SFF-TA-1031 Rev 0.0.2

SFP2 Cage, Connector, & Module Specification

Rev 0.0.2 February 11 August 18, 2022

Rev 0.0.2 August 18, 2022
-Changed Unmating force from 12.5N Max to 30N max
-Replaced Figure 5-2 with new figure showing 1.2 max for width of locating peg.

Figure 7-2 SFP2 Improved Module Paddle Card Dimensions

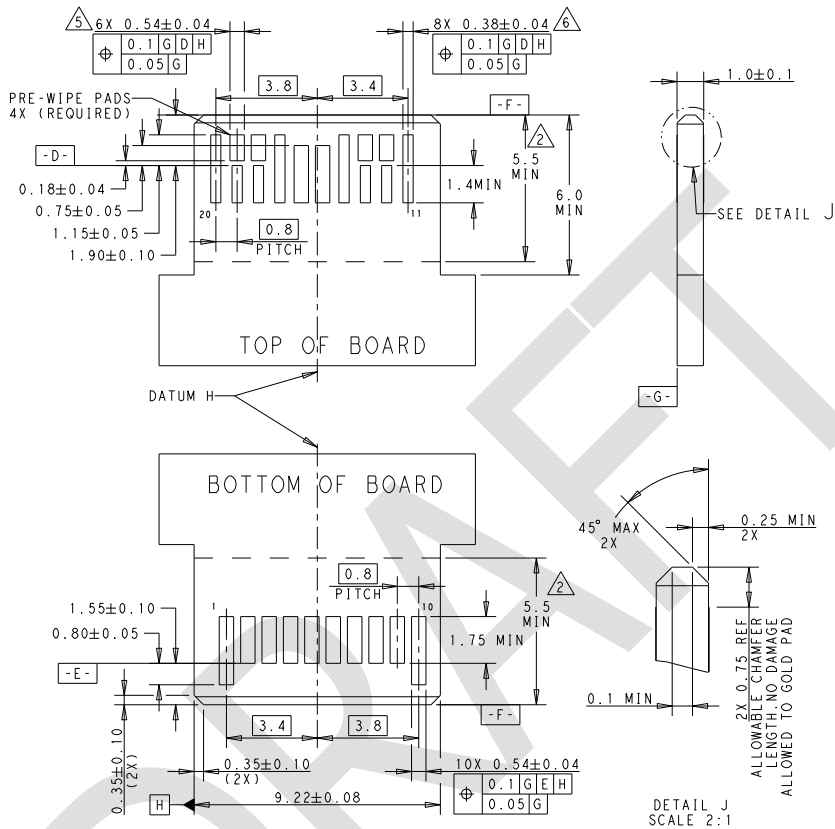
Commented [GD1]: Alternate Plating: cannot put that Pd on practically. Leave it in as it has been on many documents in the past. If testing shows a better plating, change it then. The one being looked at is IPC-4556: 0.03 Au, 0.05 Pd, 3.0 Ni
